**CHANGE ORDER FORM**

Change Order No. 01  
Project Title KWRU Filter & CCC Replacement  
Bid No. 02  
Owner: Key West Resort Utilities Corp.  
Contractor: Wharton Smith  
Agreement Date: 4/18/ 2018

Re: Change Order Proposal No. 01 Revision 1  
KWRU Filter Replacement  
Generator Replacement

# KWRU WWTP GENERATOR REPLACEMENT

EXISTING CONDITIONS

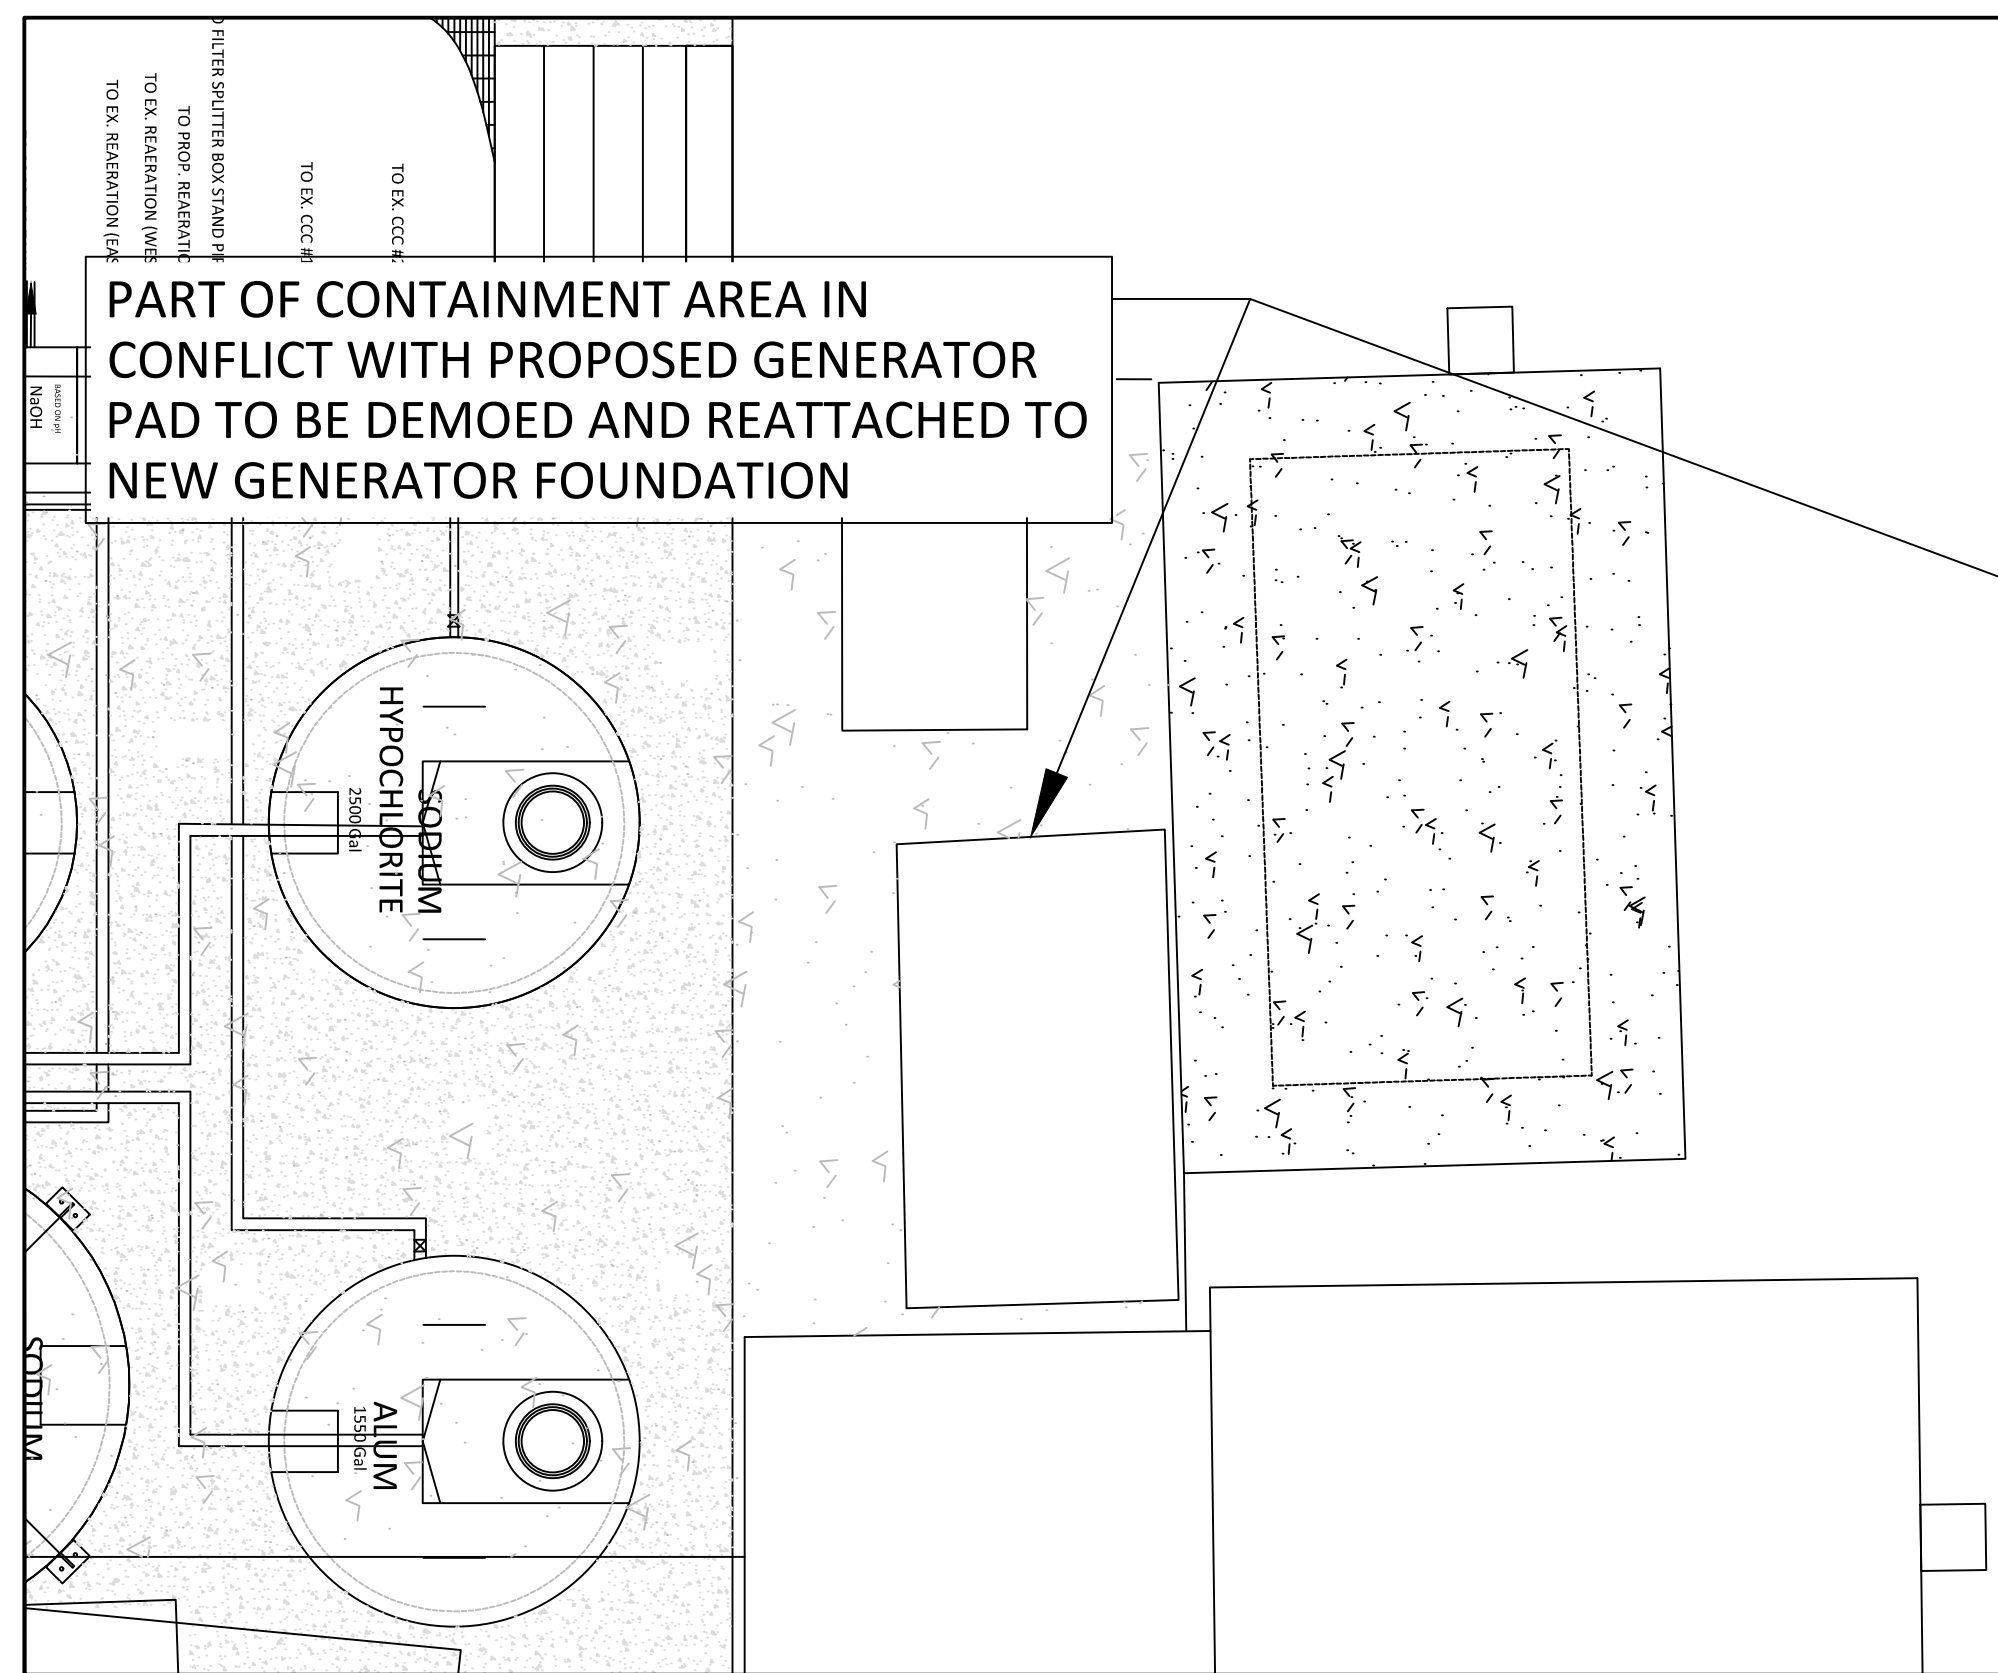
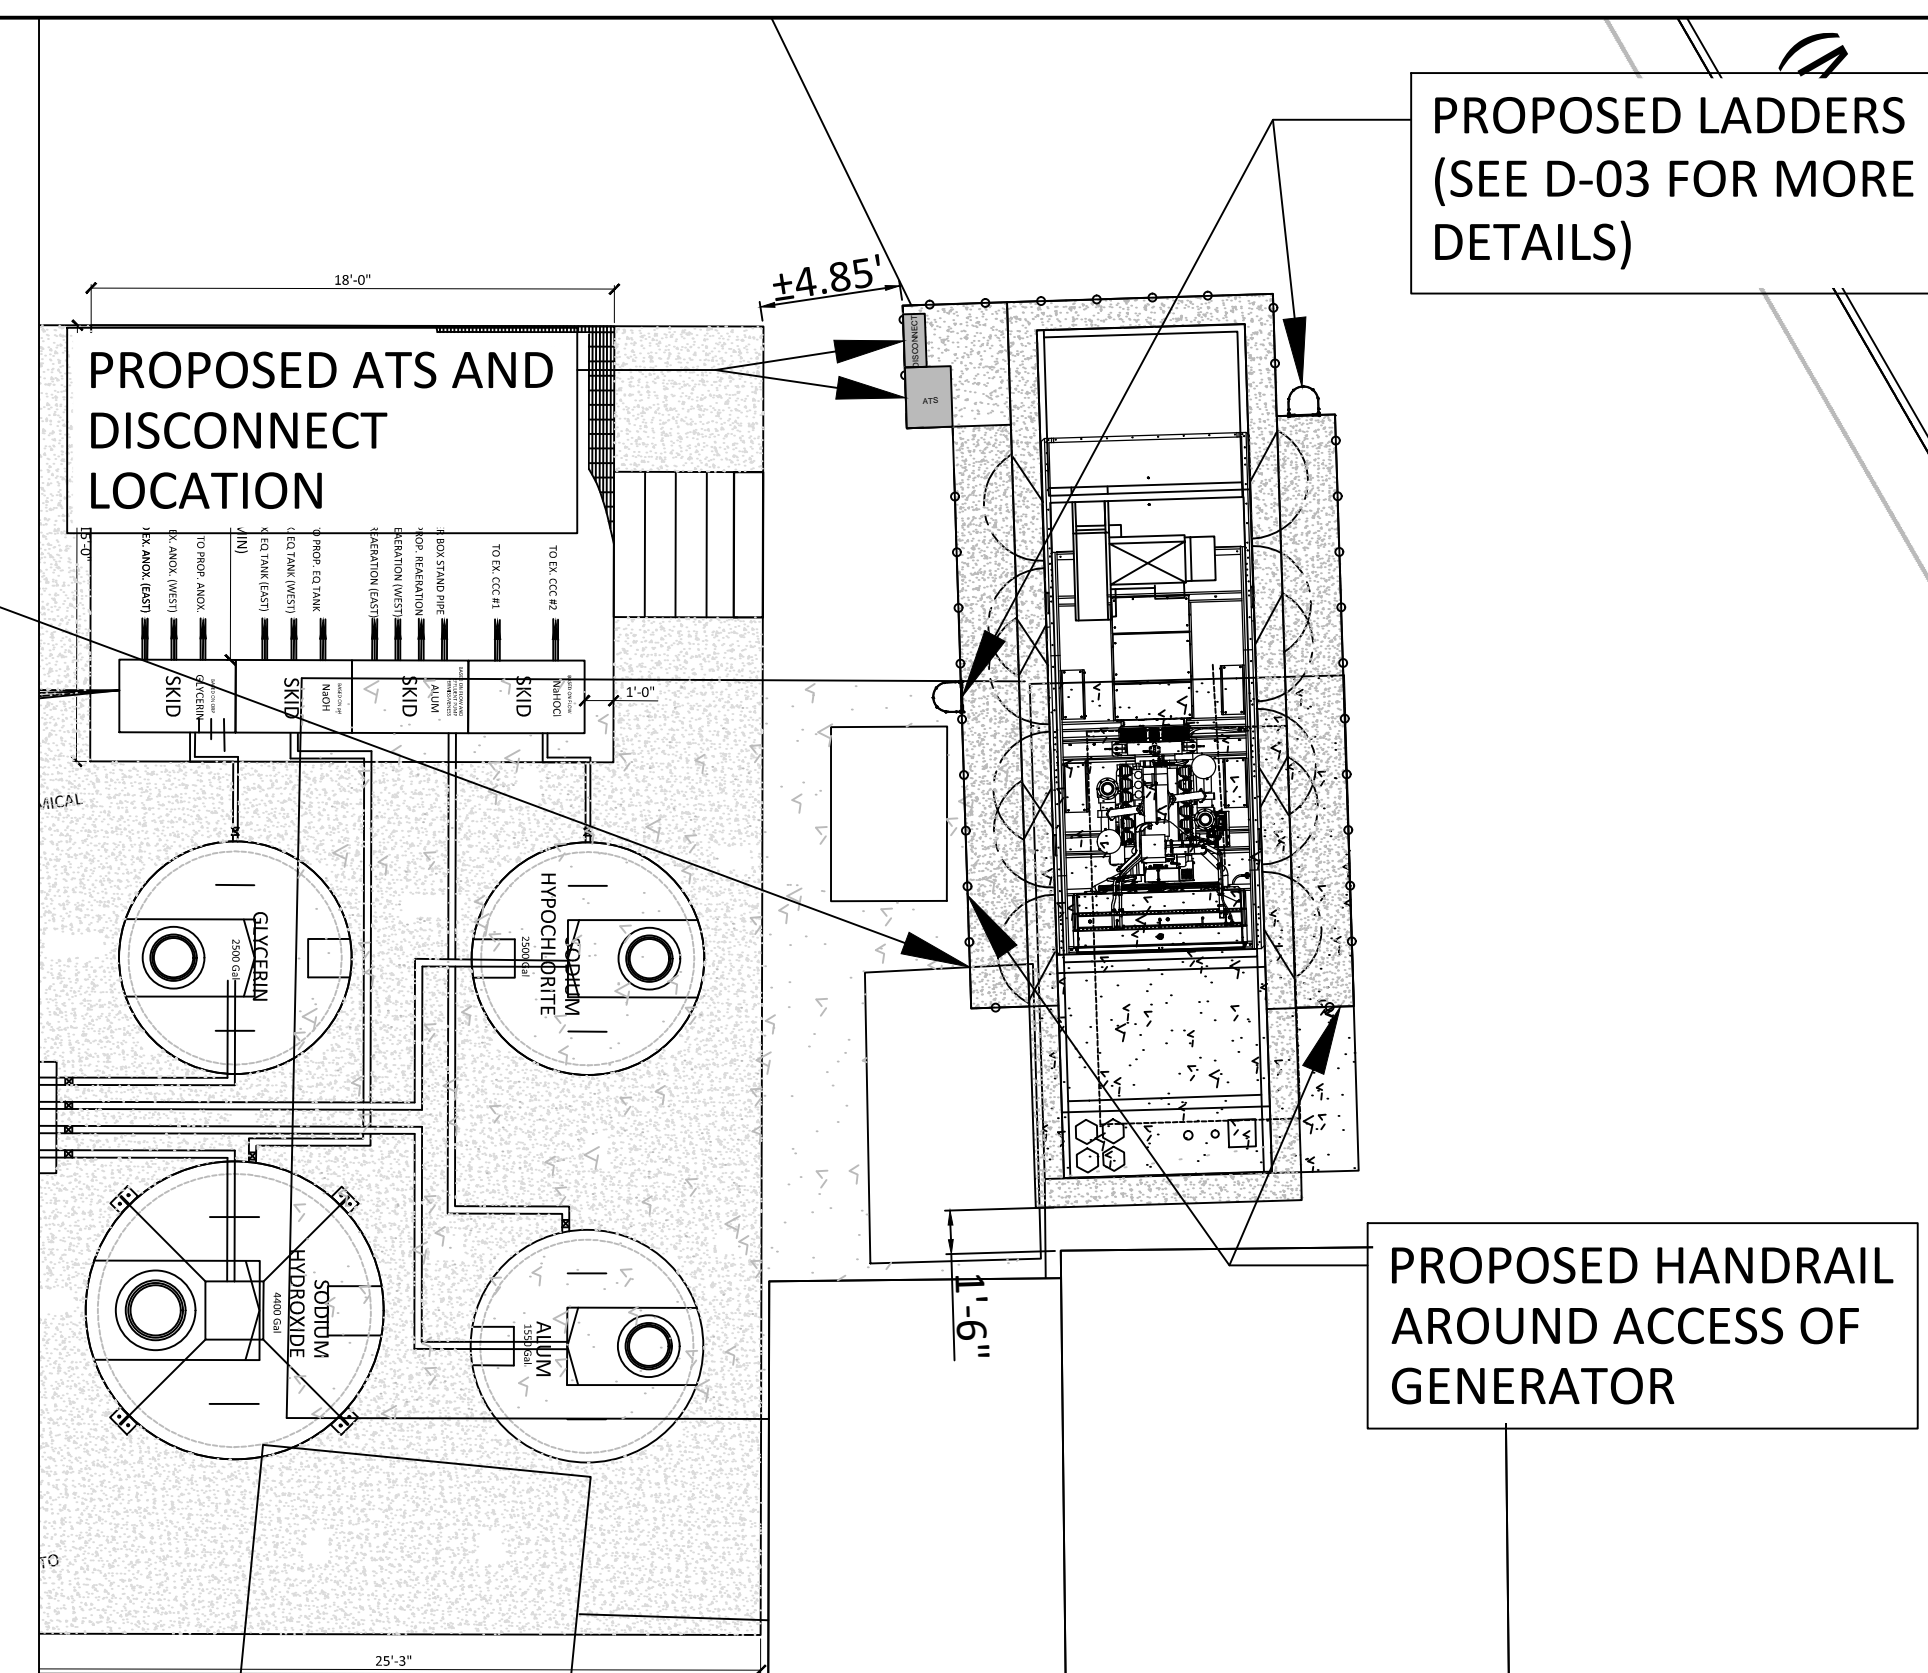
**Description of Change:** Installation of new standby generator and foundation.

**Reason for Change:** Original backup generator is no longer functional and is beyond its service life.

- Demolition & removal of the existing generator. Coordinate with KWRU staff if they would like to salvage any part of the generator prior to disposal.

- Demolition of the existing external fuel tank containment area. Fuel tank shall remain the property of KWRU and will be relocated on the site to an area designated by KWRU staff.

PROPOSED CONDITIONS
